ERL Consensus Discussion

For the purpose of closing comments on Draft 1.2

ERL Comments

COM vs ERL using Varying Eta_0 Values

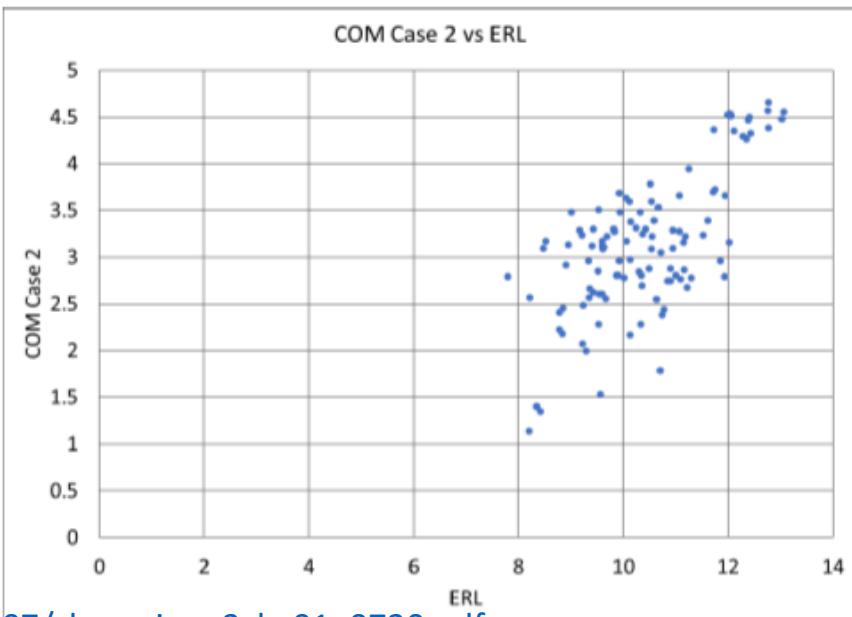
- Plot on right shows COM vs ERL for 110 channels
- Min ERL is 8.7
- A min ERL of 8 is recommended for specification to allow room to limit for other forms factors in addition to cable assembly and connector variation
